MORGAN AND MORECAMBE OFFSHORE WIND FARMS: TRANSMISSION ASSETS

Annex 2.4 to Applicants' Response to Deadline 3 submissions from Statutory Consultees and other organisation: Lancashire County Council (REP3-084)

Document Numbers:
MRCNS-J3303-JVW-19135MOR001-
FLO-CON-CAG-RPT-0115
Document Reference: S_D4_2.4

Table 2.1: REP3-084 – Lancashire County Council's Responses to ExQ1

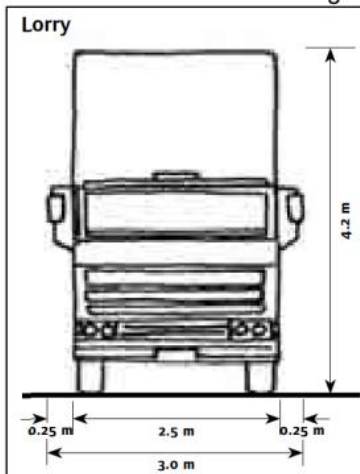
Reference	ExA Question	LCC Response	Applicants' response
		<p>especially in the rural locations. However, agreement has recently been made on locations for further surveys (non-motorised users) this will enable a greater understanding of safety and any issue that will need addressing as a consequence of additional HGV's using the network. The County Council awaits the results of these surveys and the information to be shared before further discussions can take place.</p> <p>The sections of highway that require mitigation have not yet been agreed and currently there is no certainty that mitigation yet to be proposed is deliverable within land controlled by the applicant or the County Council. The current oCTMP only proposes mitigation at highway links that have a carriageway width of less 5.0m.</p> <p>Whilst the oCTMP proposes some generic mitigation measures, the County Council requires further detail with regards to the number of HGV movements in and out of each access and need a refinement of the Traffic Management measures/mitigation that has regard to each location/pinch point/corridor.</p> <p>The deliverability and whether the principles of the generic mitigation can operate at specific locations is yet to be presented.</p> <p>The County Council are willing to consider mitigation proposals, but the principles of the mitigation measures must be demonstrated to be deliverable and operational for each specific highway link, as each link has its own unique</p>	<p>accordingly, there are established industry tried and tested measures to address the effects of HGVs in these circumstances. The Applicants have outlined these within the oCTMP (REP2-016).</p> <p>With reference to sustainable highway users, the Applicants refer to Section 7.5 of Volume 3, Chapter 7: Traffic and Transport of the Environmental Statement (APP-108) which contains details of the approach to defining the baseline highway environment. Noting the vast transport and traffic study area, a proportionate methodology was employed, that consisted of a review of the highway environment and sensitive receptors and the affected road user groups (Table 7.12).</p> <p>The Applicants have agreed to LCCs request for confirmatory checks and have commissioned a sample non-motorised user survey (the scope of which was agreed with LCC). The survey results have been collated and will be shared with LCC following D4.</p> <p>The Applicants and LCC have agreed to meeting following Deadline 4 to discuss these links to agree where the Parties consider that mitigation would be required and the deliverability. To inform this meeting, the Applicants are preparing plans and a note that draws together key metrics, these include:</p> <ul style="list-style-type: none"> • The existing road width (from onsite measurements) at regular intervals; • The existing highway width (from onsite measurement) at regular intervals, e.g. the width of verges either side where vehicle wing mirrors can oversail or where widening could be provided; • The existing levels of use by Heavy Vehicles (HVs) from traffic surveys;

Reference	ExA Question	LCC Response	Applicants' response
		<p>constraints.</p> <p>Extract: Manual for Streets Figure 6.18.</p>  <p>The diagram shows a front view of a lorry. The height is indicated as 4.2 m. The width is indicated as 3.0 m, with a central section of 2.5 m and 0.25 m on either side.</p>	<ul style="list-style-type: none"> The forecast levels of use by the Transmission Assets HV traffic at peak and on average; and Levels of non-motorised user traffic at key links. <p>This information will inform the scale of the highway constraints and refinement of a proportional mitigation plan.</p>
Q16.1.15	<p>Routing strategy for HGVs</p> <p>Do you consider that the applicants will be able to demonstrate to you the suitability of all the links in the proposed routing strategy for HGVs. Are there some links that you consider will remain unsuitable whatever measures the applicants propose?</p>	<p>Please refer to LCC Response above (Q16.1.14). In addition, the County Council cannot rule out the suitability of highway links at this stage. However, sufficient information has not been presented to date that ensures all highway links can be made suitable with appropriate mitigation.</p>	<p>The Applicants refer to the response to Q16.1.14 above. The Applicants are committed to working proactively with LCC to agree the scale of highway constraints. This will determine if any further detail regarding the application of measures outlined in the oCTMP (REP2-016) is required during the examination.</p>
